Access Compliance Report

Public Rights-of-Way

(Curb Ramps)

Intersection ID: 31447	Main Street: RIDING_HILL_AV	Cross Street: GLENLUCE_AV	Location: SE
ADA ID: 2C0690CBCC7F	Ramp Type: PerpDiag	Initial Pass/Fail: Fail	Overall Compliance: No
		Severity Score: 10

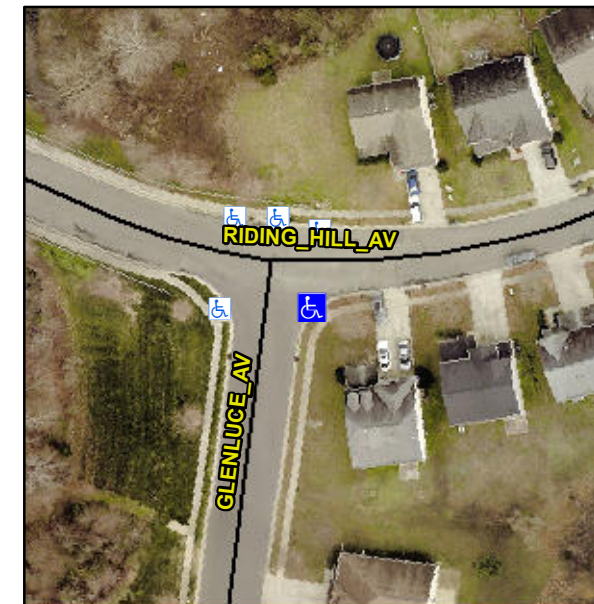
Not Found, R304.5.1, R304.5.3

Compliance	Description	Data	Compliance	Description	Data
N/A	Ramp Length (in)	48.0	Yes	Ramp Slope (%)	8.3
No	Ramp Width (in)	43.0	No	Ramp XSlope (%)	2.3
N/A	Flare Type LT	N/A	N/A	Flare Type RT	N/A
N/A	Flare Slope LT (%)	N/A	N/A	Flare Slope RT (%)	N/A
N/A	Flare Traversable LT?	N/A	N/A	Flare Traversable RT?	N/A
N/A	Landing Length (in)	N/A	N/A	DWS Provided?	N/A
N/A	Landing Width (in)	N/A	N/A	DWS Contrast?	N/A
N/A	Landing Slope (%)	N/A	N/A	DWS Length (in)	N/A
N/A	Landing X Slope (%)	N/A	N/A	DWS Full Width?	N/A
N/A	Landing Curb? (Y/N)	N/A	N/A	DWS Offset (in)	N/A
N/A	Shared Landing?	N/A			
N/A	Gutter Ponding?	N/A	N/A	Gutter Slope (%)	N/A
N/A	Gutter Lip Ht (in)	N/A	N/A	Gutter X Slope (%)	N/A
N/A	Painted X Walk1?	No	N/A	Painted X Walk2?	No
	X Walk 1 Direction	To N		X Walk 2 Direction	To W
N/A	X Walk 1 Width (in)	N/A	N/A	X Walk 2 Width (in)	N/A
	X Walk 1 Slope (%)	1.6		X Walk 2 Slope (%)	6.7
	X Walk 1 X Slope (%)	5.3		X Walk 2 X Slope (%)	0.9

Remove & Replace Curb Ramp With Two New Directional Ramps or Equivalent.
